June 12, 2023
Subject: Large Culvert Replacement
State WIN: 025397.00
Location: **Arundel**
Amendment No. 2

Log Cabin Road Culvert Replacement
Project No. 25397.00P
Arundel, Maine
13'-0" x 8'-0" Split Box Culvert - End Views, C.O. Wall Layout & Details
Scale: AS SHOWN
Designed by: BA/W
Drawn by: DJF
Checked by: XXX
Date: 10/7/2023
Project No. 13788

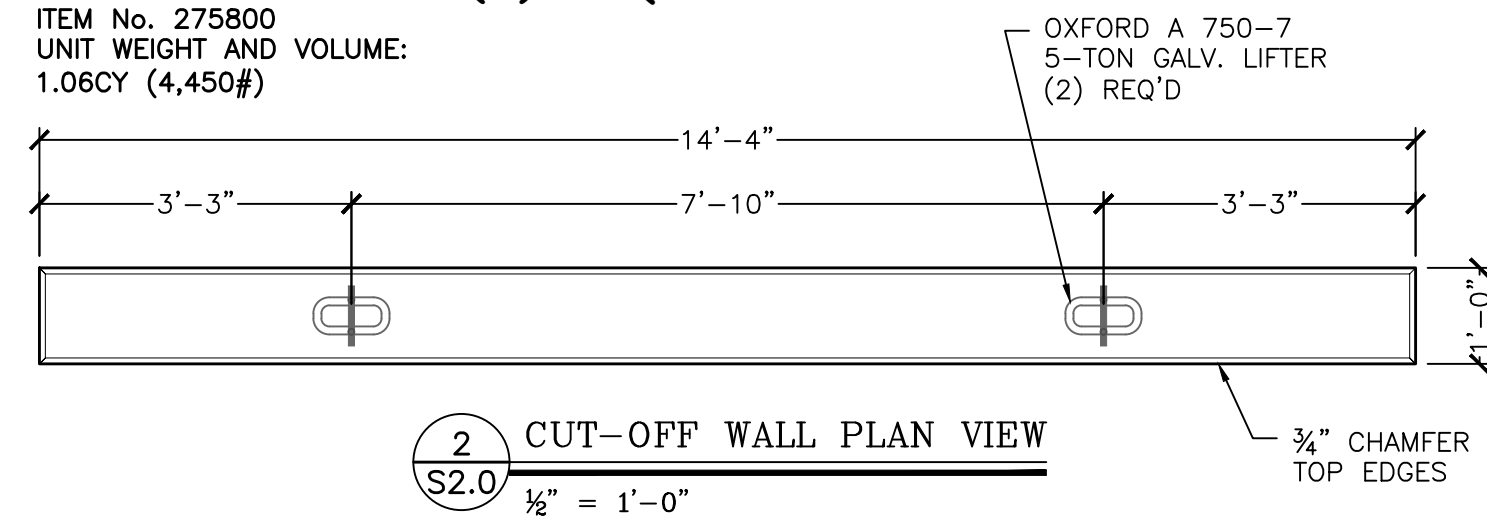
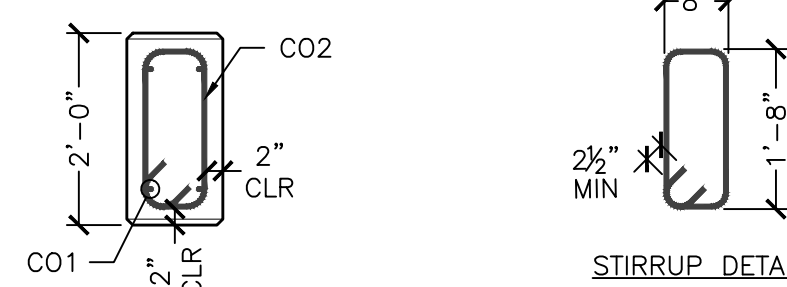
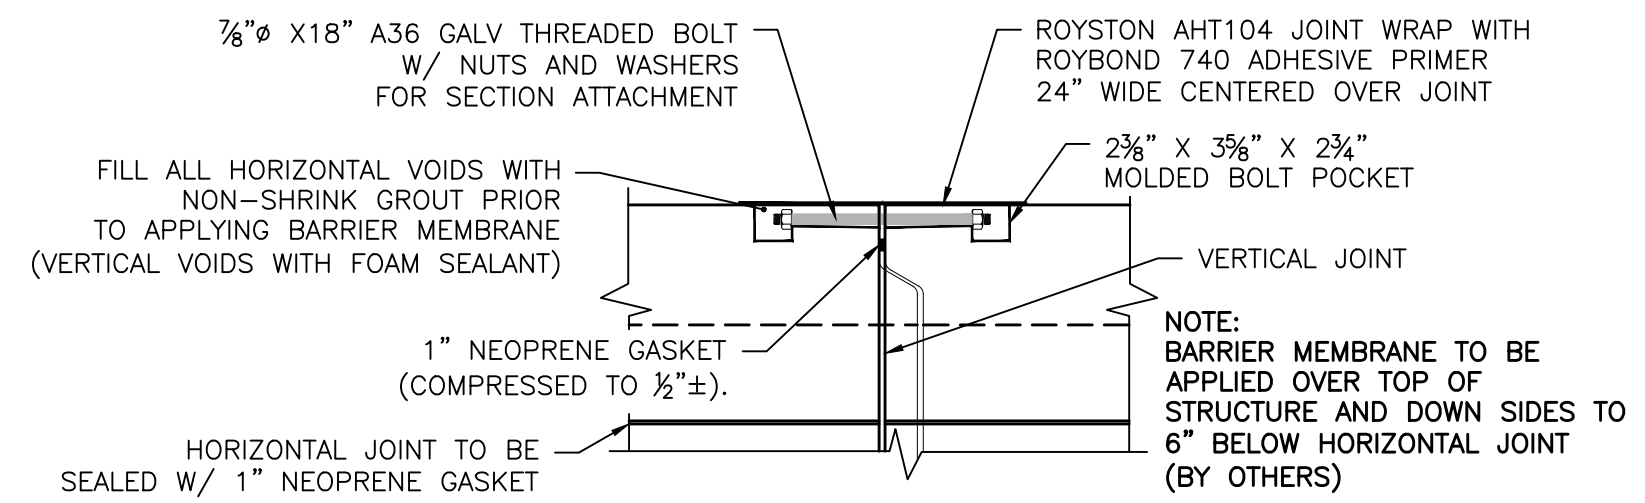
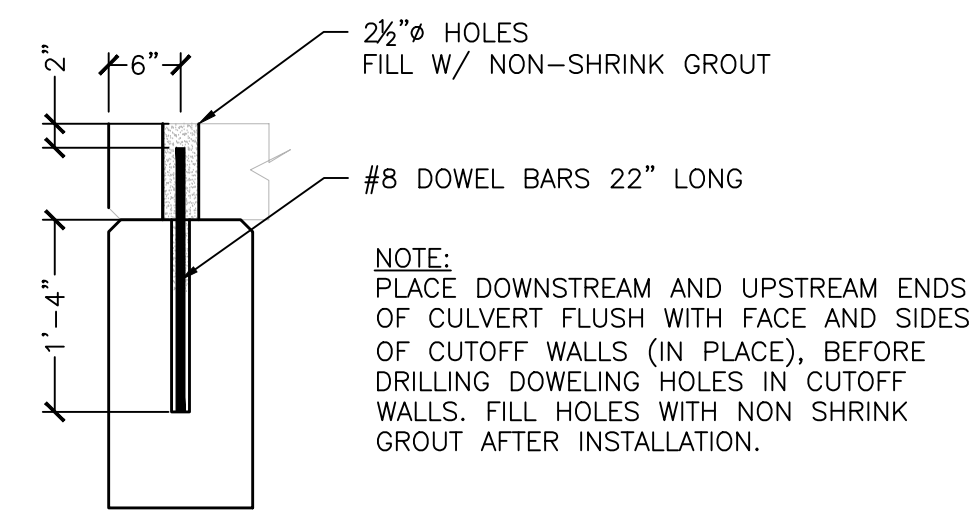
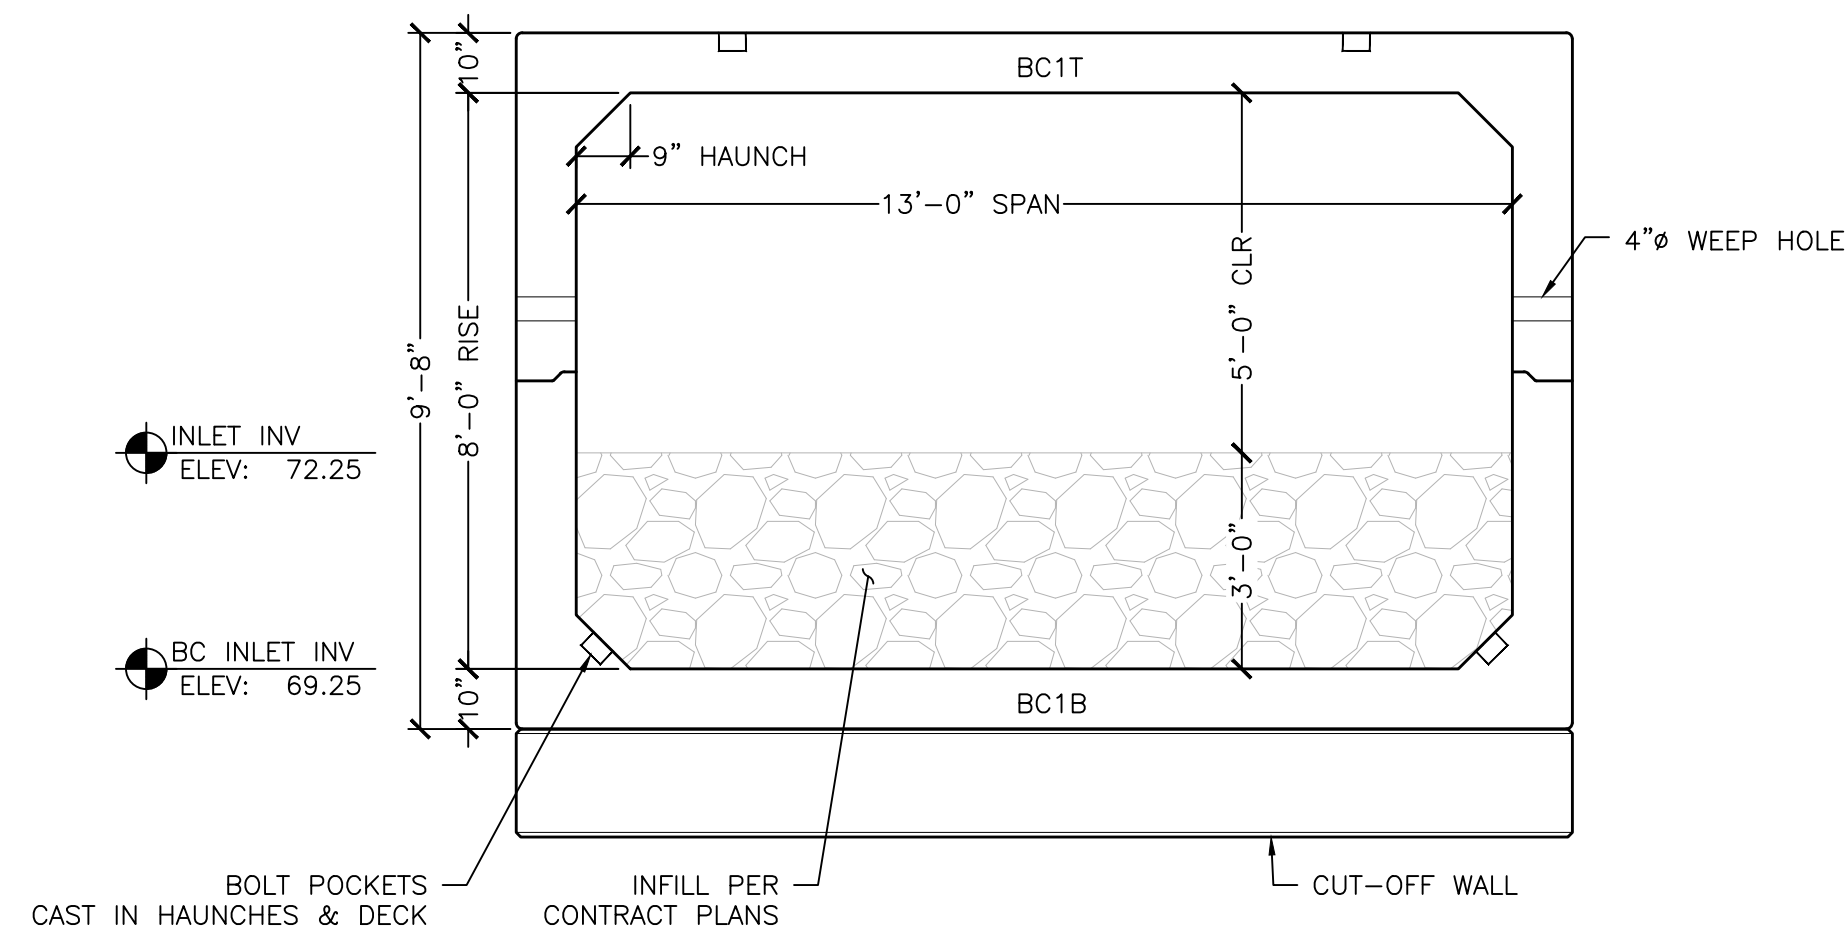
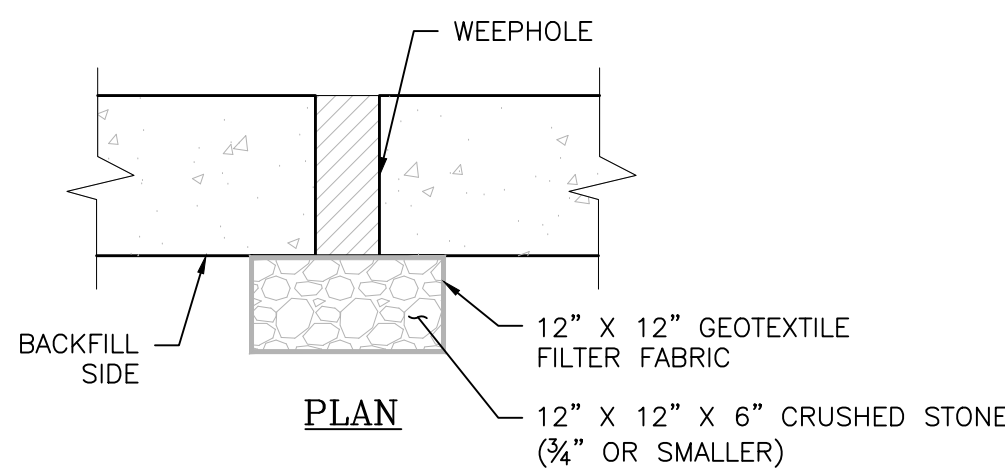
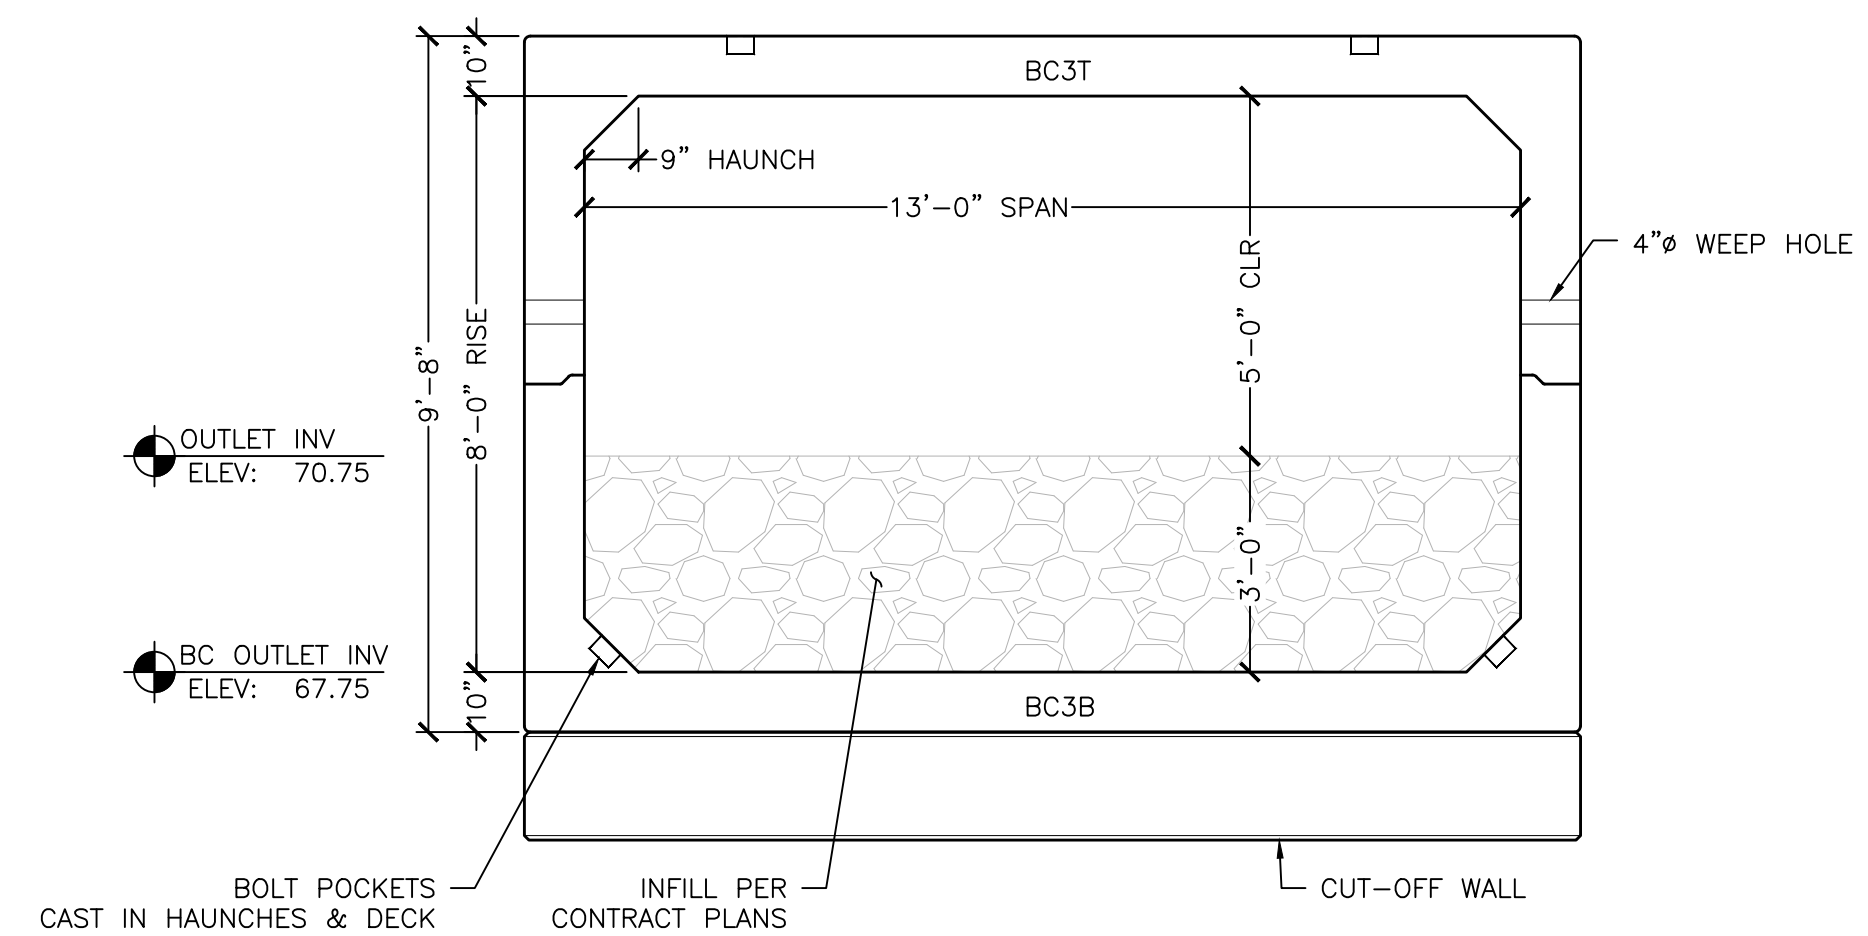
Question: I am requesting all pertinent information for the State Supplied box culvert at this time to help me prepare my bid. If preliminary shop drawings are available and could be sent that would be wonderful. Here is a list of items I am interested in learning:

- * Overall dimensions of each section of box culvert.
- * Weight of the heaviest section.
- * Number of sections.
- * Delivery schedule (how many pieces can be delivered per day).
- * Installation instructions.
- * Any other relevant information available.

For information not included in the Shop Drawing attached contact Michie Concrete Products of Henniker NH.
